STAFF RECOMMENDATION 1409 Gartland Avenue July 21, 2021

Application: New Construction—Addition and Outbuilding
District: Lockeland Springs-East End Neighborhood Conservation Zoning Overlay
Council District: 06
Base Zoning: R6
Map and Parcel Number: 08309032800
Applicant: Matt Lewis, Architect
Project Lead: Sean Alexander, sean.alexander@nashville.gov

<p>Description of Project: The applicant proposes to construct a rear addition to an historic house and to alter the window rhythm and proportion on a projecting bay on the right side of the house, and to construct a detached outbuilding at the rear of the lot.</p> <p>Recommendation Summary: Staff recommends approval of the proposed addition and outbuilding with the following conditions:</p> <ol style="list-style-type: none">1. The partial demolition is accomplished manually, and the applicant be required to submit a demolition and shoring plan;2. The material of the rear porch columns and the window and door selections are approved prior to construction;2. The outbuilding has a roof pitch of at least 4/12;3. The outbuilding's eaves do not extend more than two feet (2'); and4. The outbuilding is constructed of compatible materials. <

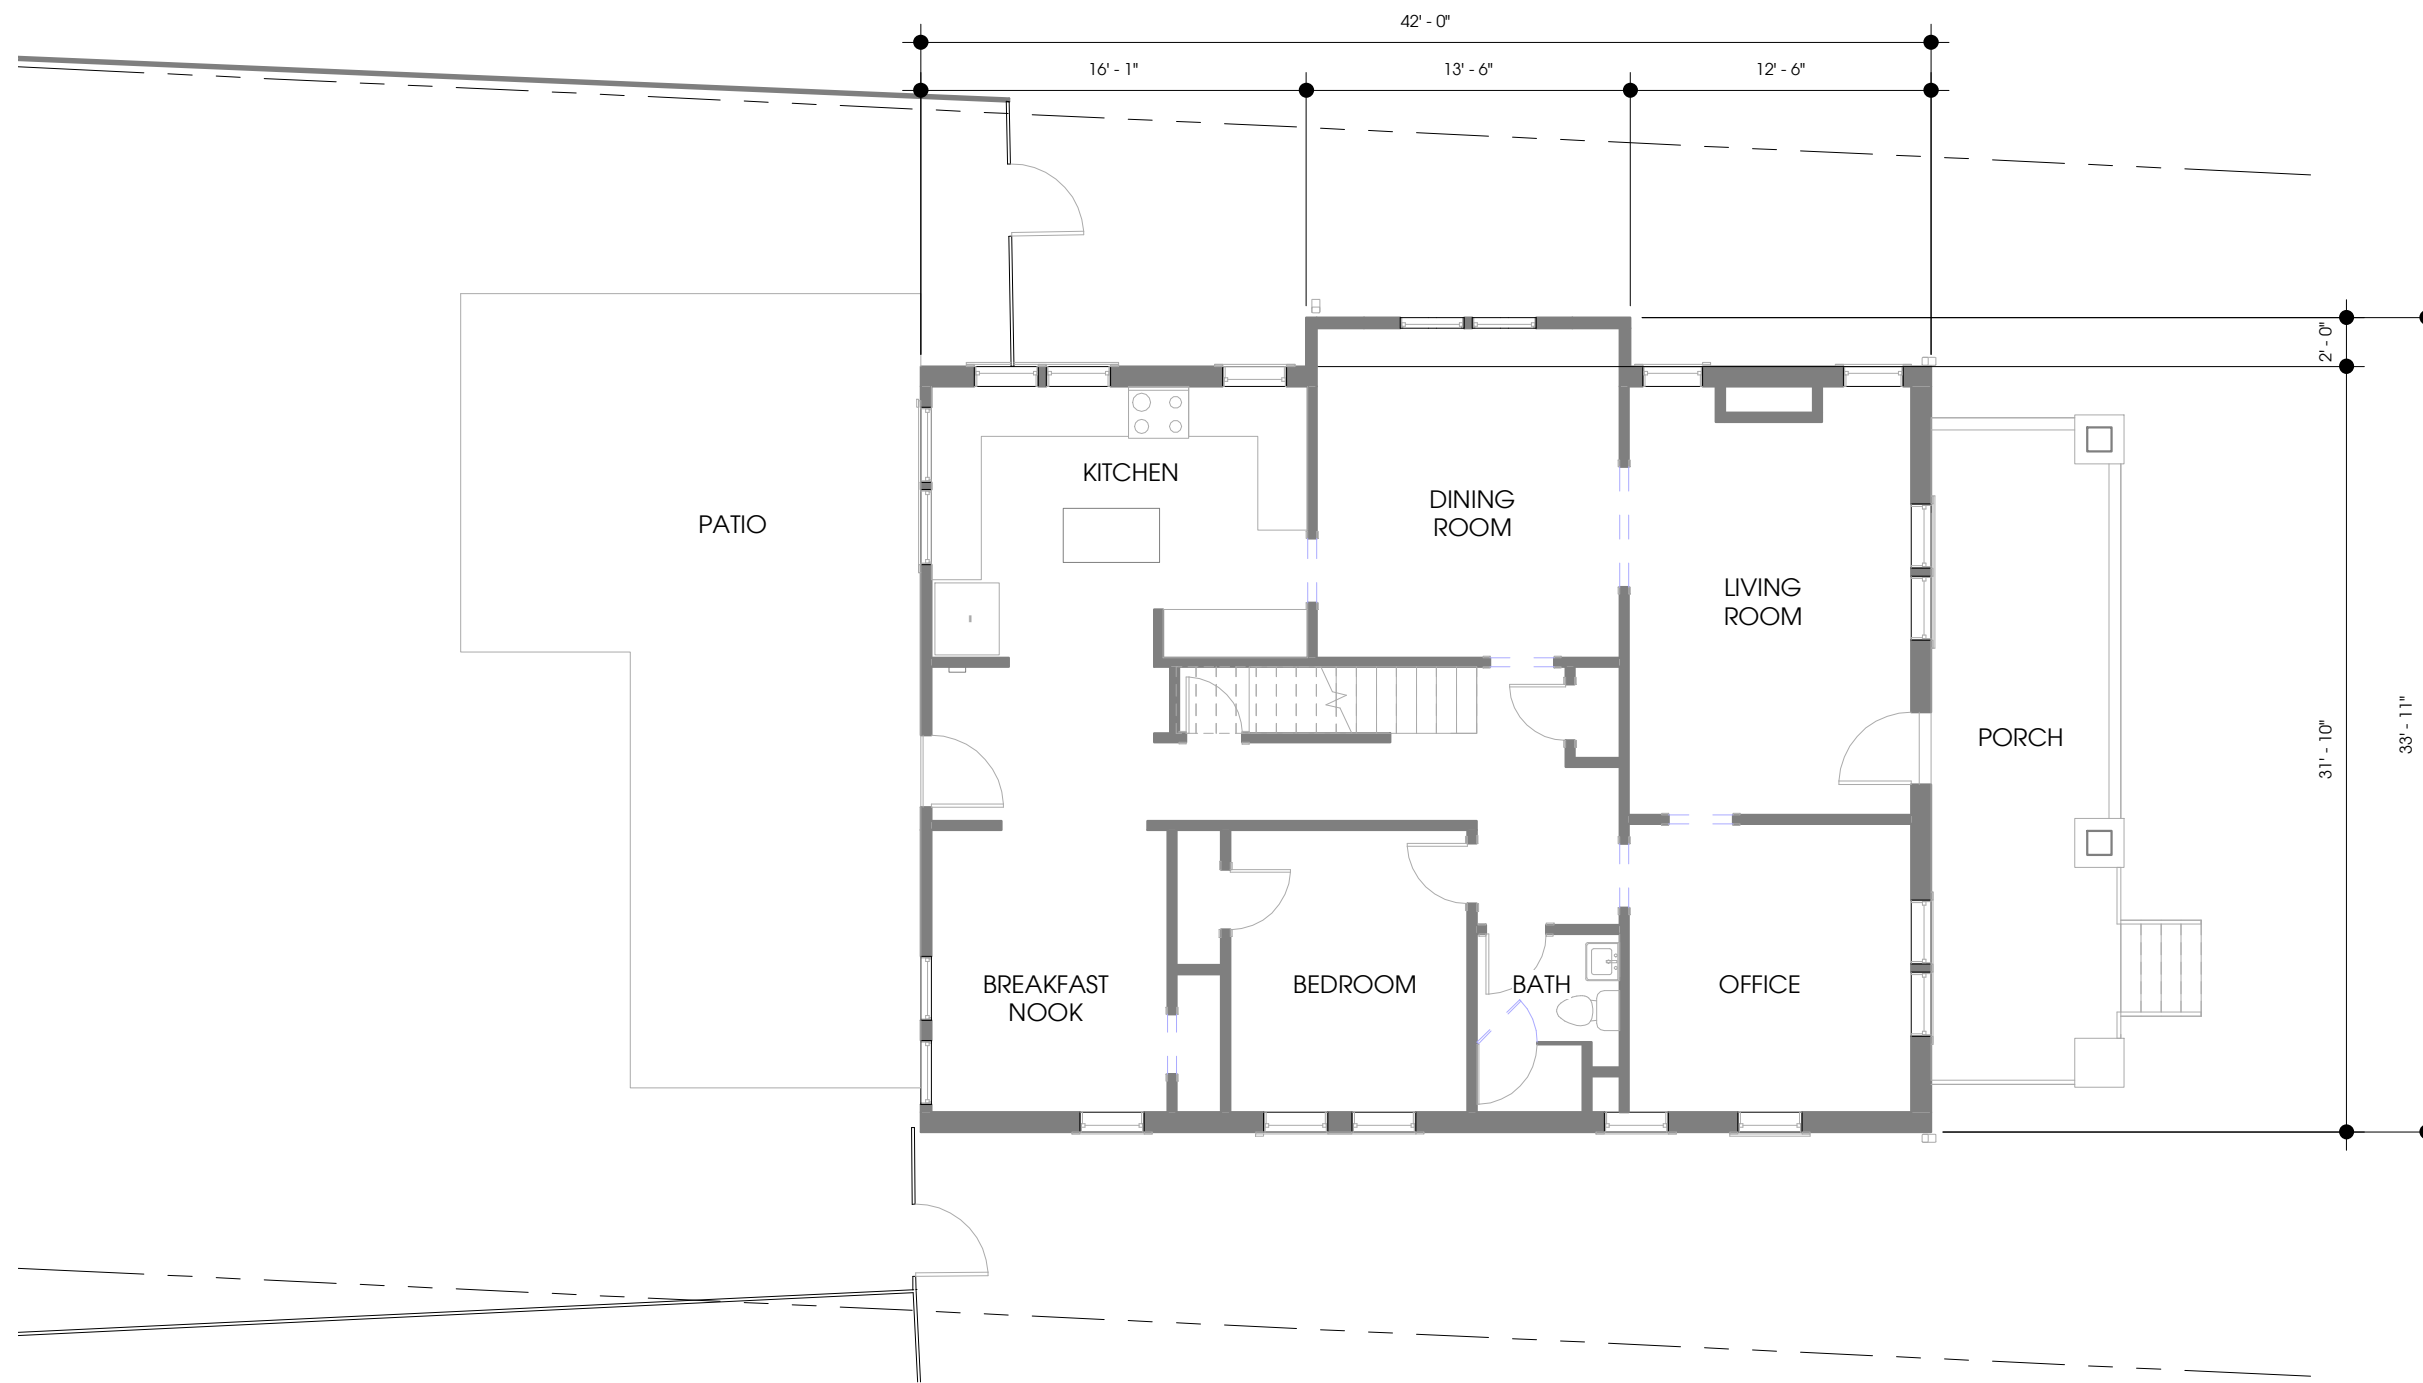
Staff finds the exposed steel framing to be inappropriate, and to resemble a type of metal carport structure that is not typical of the historic neighborhood. Staff finds that the steel framing does not meet IV.B. of the design guidelines.

With a condition that the outbuilding has a roof pitch of at least 4/12, eaves that do not extend more than two feet (2'), and is constructed of compatible materials, Staff finds that the outbuilding meets section IV of the design guidelines.

1. The partial demolition is accomplished manually, and the applicant be required to submit a demolition and shoring plan;
2. The material of the rear porch columns and the window and door selections are approved prior to construction;
3. The outbuilding has a roof pitch of at least 4/12;
4. The outbuilding's eaves do not extend more than two feet (2'); and
5. The outbuilding is constructed of compatible materials.

EXISTING PLAN

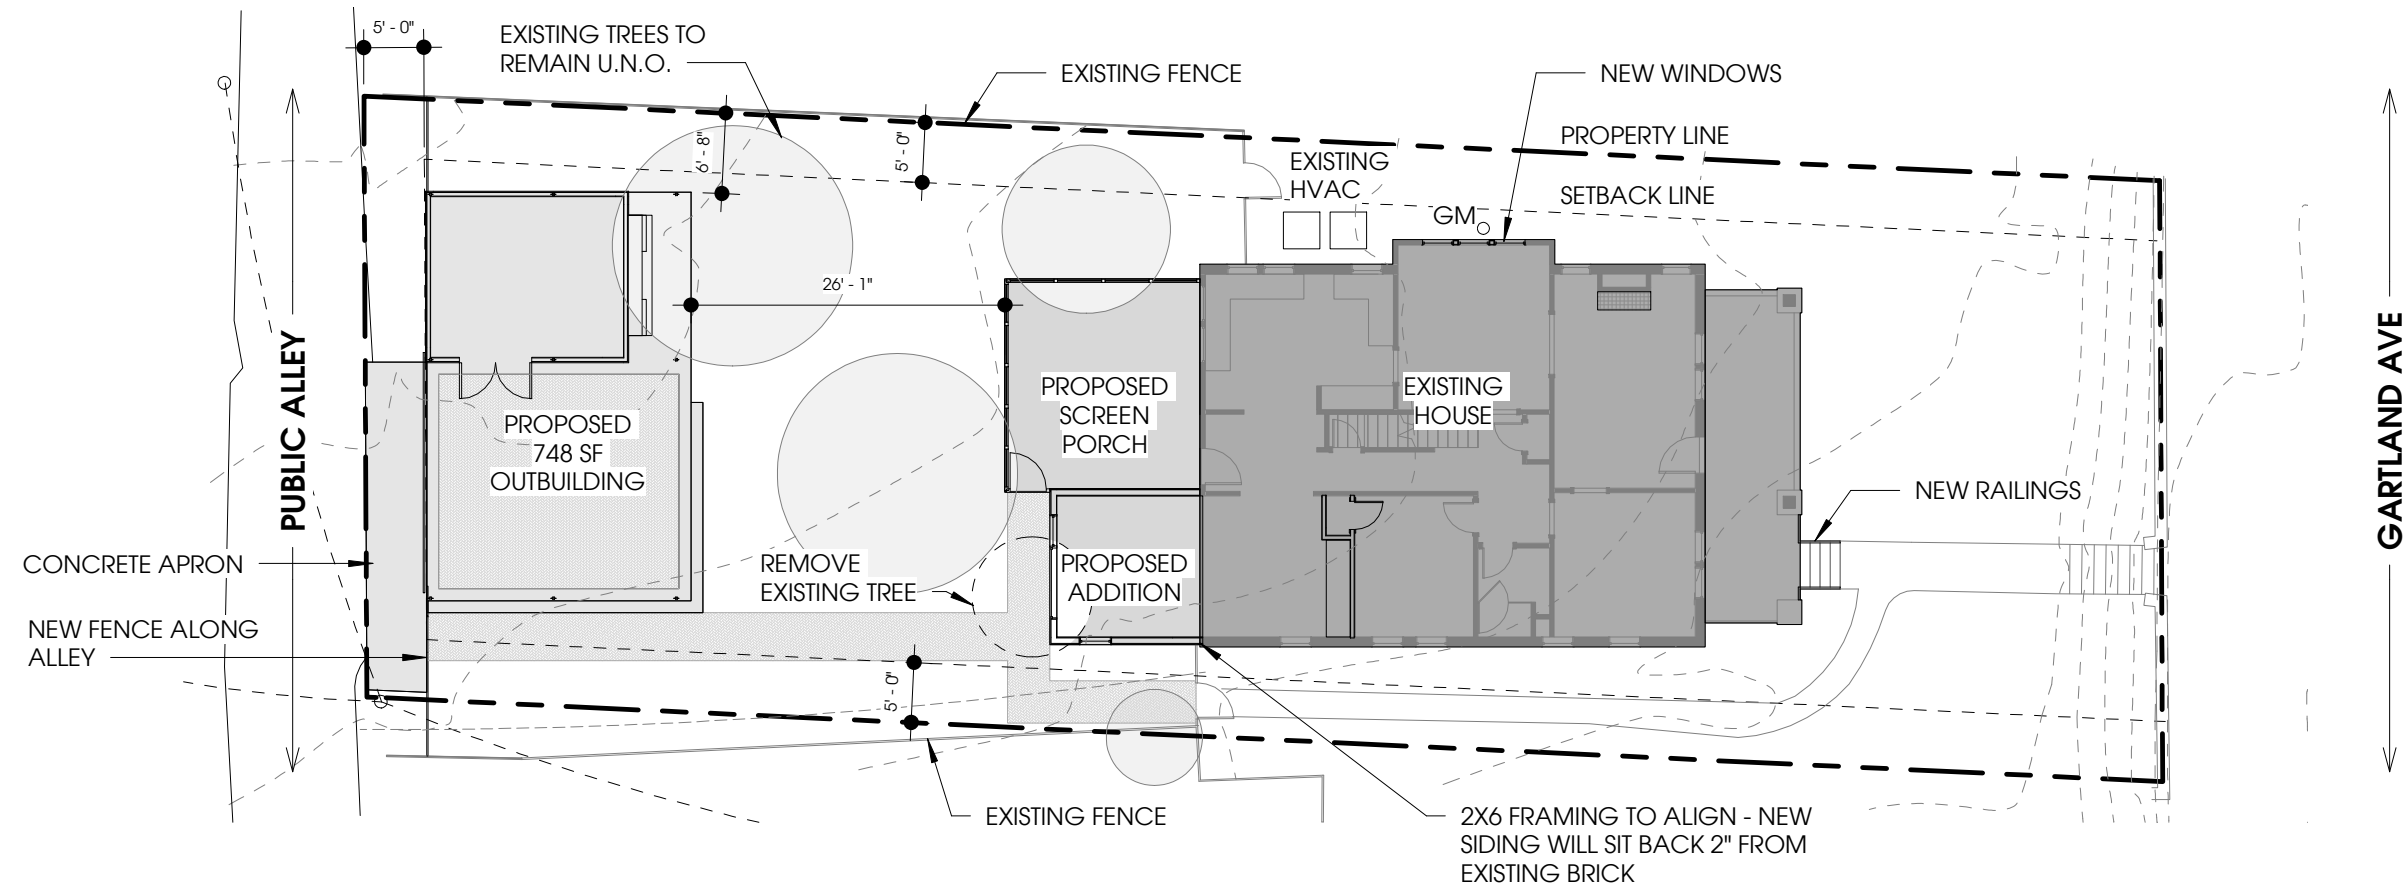
Demolition: A portion of the rear wall of the first story of the house will be removed to accommodate the proposed rear addition. Although the rear wall is original and intact, it is at the rear; therefore, it does not contribute to the historic character of the house in the same way that the front and side walls do.

The project will also replace a pair of windows in a bay on the right side of the house with three new windows. This bay is at the midpoint of the building, and the proposed window rhythm would not differ greatly from the existing window rhythm.

Staff recommends a condition that the partial demolition is accomplished manually, and the applicant be required to submit a demolition and shoring plan.

With that condition, Staff therefore finds that the demolition of a portion of the rear wall and right bay windows meets Section III.B.1.a for partial demolition.

2 OUTBUILDING - WEST ELEVATION

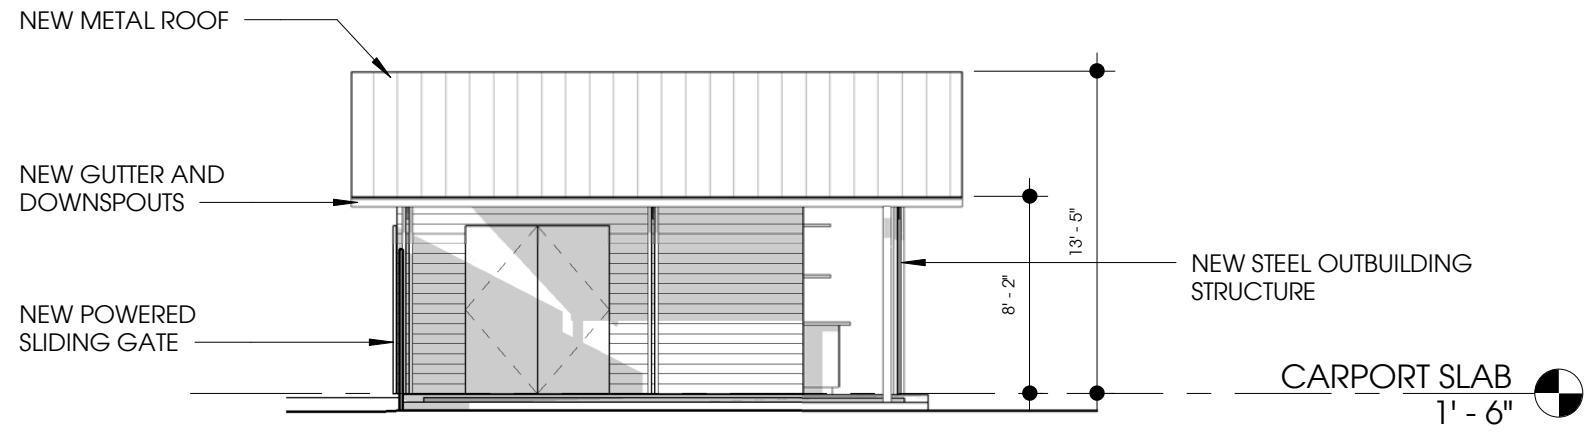
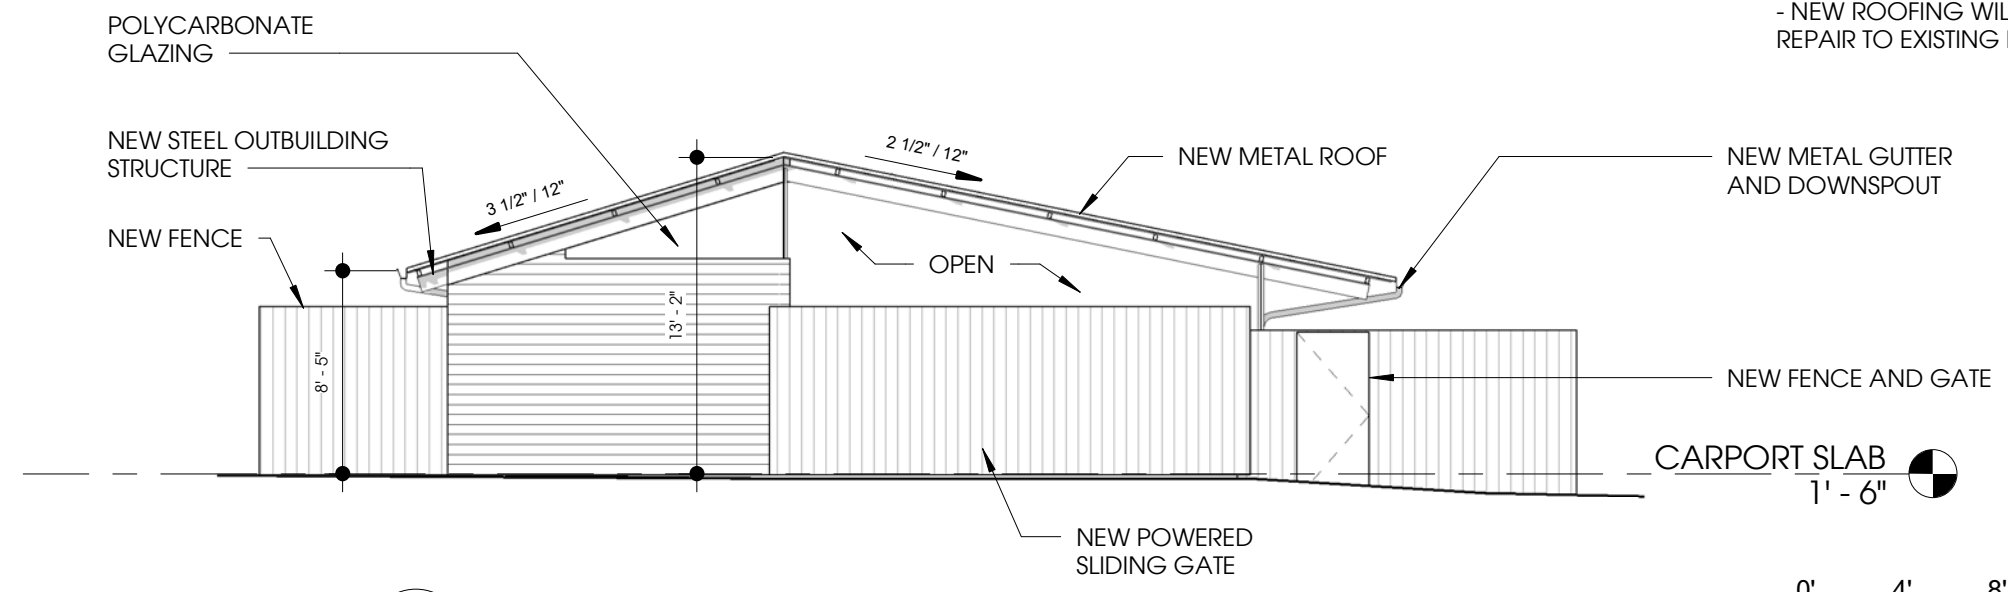
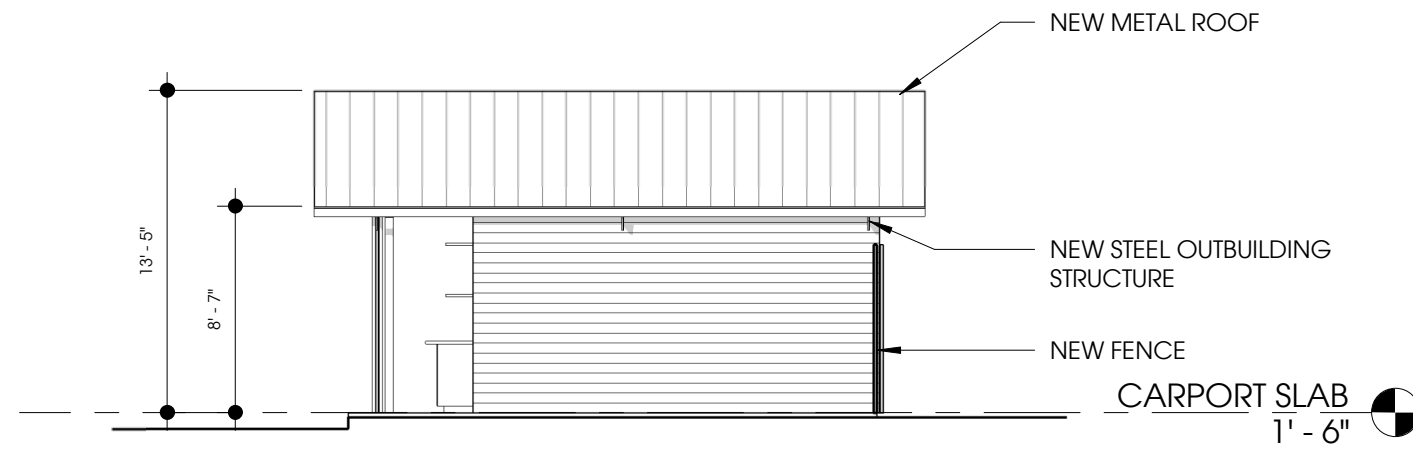
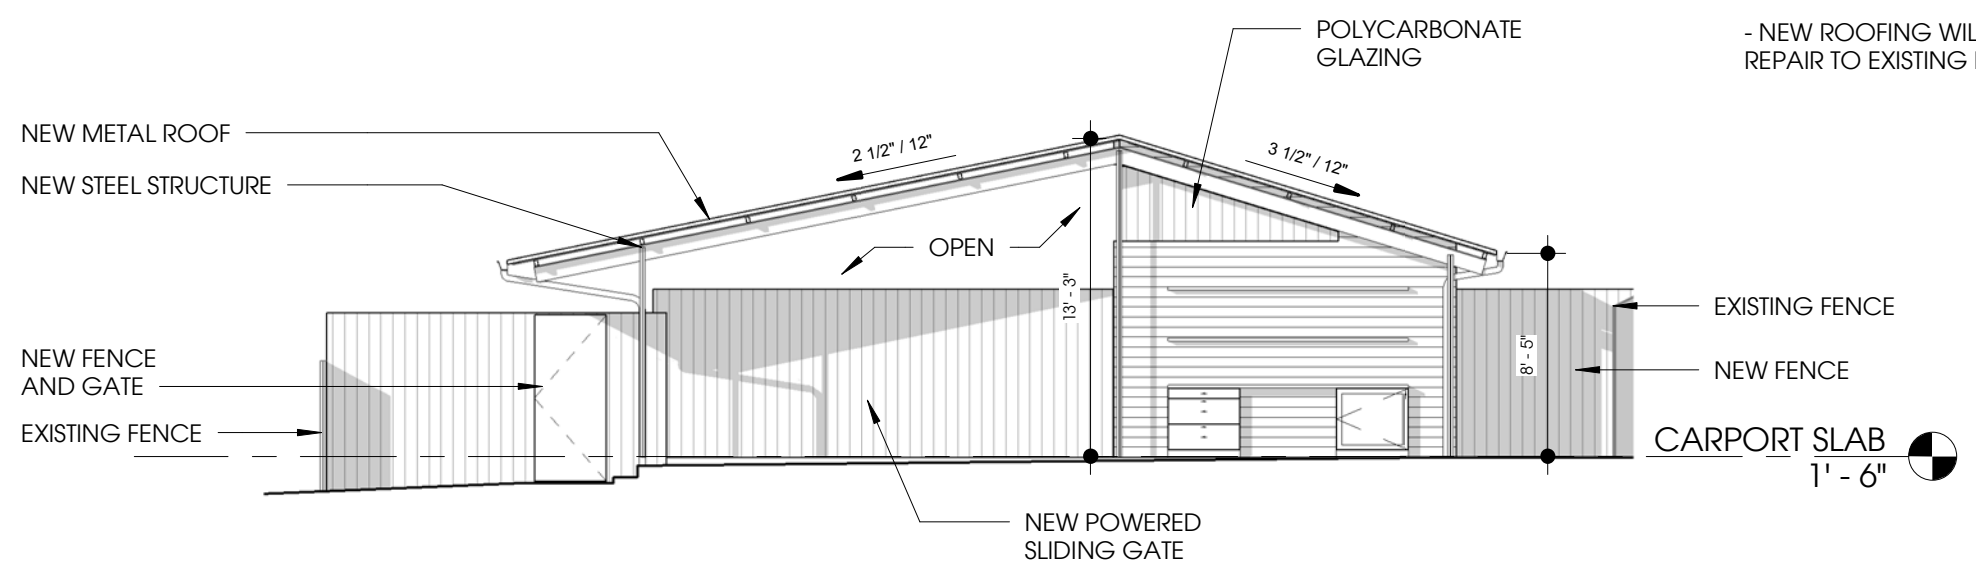
Detached Outbuildings: The proposal also includes a single-story detached outbuilding. The footprint of the outbuilding is proposed to be seven hundred, forty-eight square feet (748 sq. ft), with a ridge height of thirteen feet, five inches (13’-5”) and a wall height of eight feet, seven inches (8’-7”). The foundation and floor of the garage will be slightly above grade. The height and scale of the proposed building meet sections VII.B.1., VII.B.2 and VII.B.3. of the design guidelines for this lot, based on the lot size and the scale of the historic house.

The outbuilding is proposed to have a low-pitched roof, with a 3.5/12 pitch on the right side and 2.5/12 on the left. The eave on the right side of the outbuilding will extend one foot, nine inches (1’-9”) and the left side will extend five feet, six inches (5’-6”). The design guidelines for outbuildings say that the roof slope of an outbuilding shall be at least 4/12 and that eaves should not extend more than two feet (2’). The roof slope and eave depth of the proposed outbuilding do not meet sections VII.B.5 and VII.B.6 of the design guidelines.

The outbuilding is proposed to be constructed with a concrete floor and steel framing, with a portion to be open and exposed and a portion enclosed with cement fiberboard siding. The enclosed portion of the structure will have polycarbonate windows. The roof of the building will be standing seam metal. The floor, siding, and roof materials are appropriate and meet section IV.B.3. of the design guidelines.
